Re: Indian Point Unit 3
Docket 50-286

NL-07-121

SUBJECT: **Response to Second Request for Additional Information Regarding Relief Request 3-43 for Temporary Repair to Service Water Pipe**

REPLY TO SECOND REQUEST FOR ADDITIONAL INFORMATION
REGARDING INDIAN POINT 3 RELIEF REQUEST 3-43 FOR
TEMPORARY NON-CODE REPAIR TO SERVICE WATER PIPING

Report No. IP3-UT-07-111

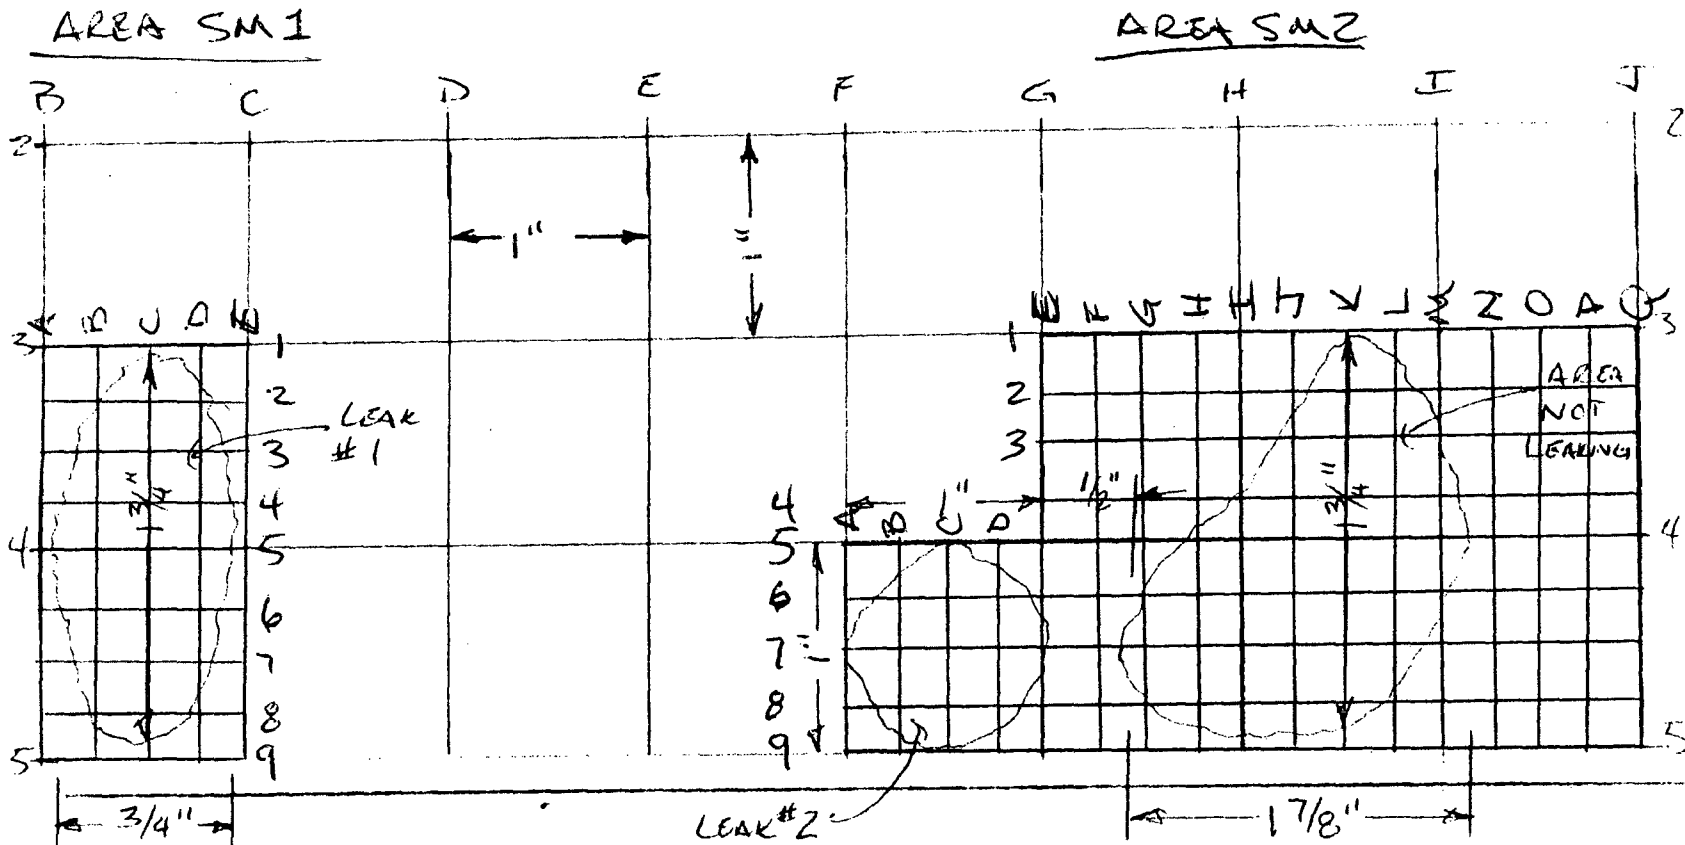
Please provide the UT report for the measurements recently taken using a ¼-inch grid.

UT Report IP3-UT-07-111 using the ¼-inch grid is provided in Attachment 2. This UT exam provides for a more detailed inspection of two regions within the coverage of the UT exam previously performed with a 1-inch grid as documented in UT Report IP3-UT-07-110.

Comments: Sketch of sub-micro grid shown below superimposed over the micro grid established by report IP3-UT-07-110.
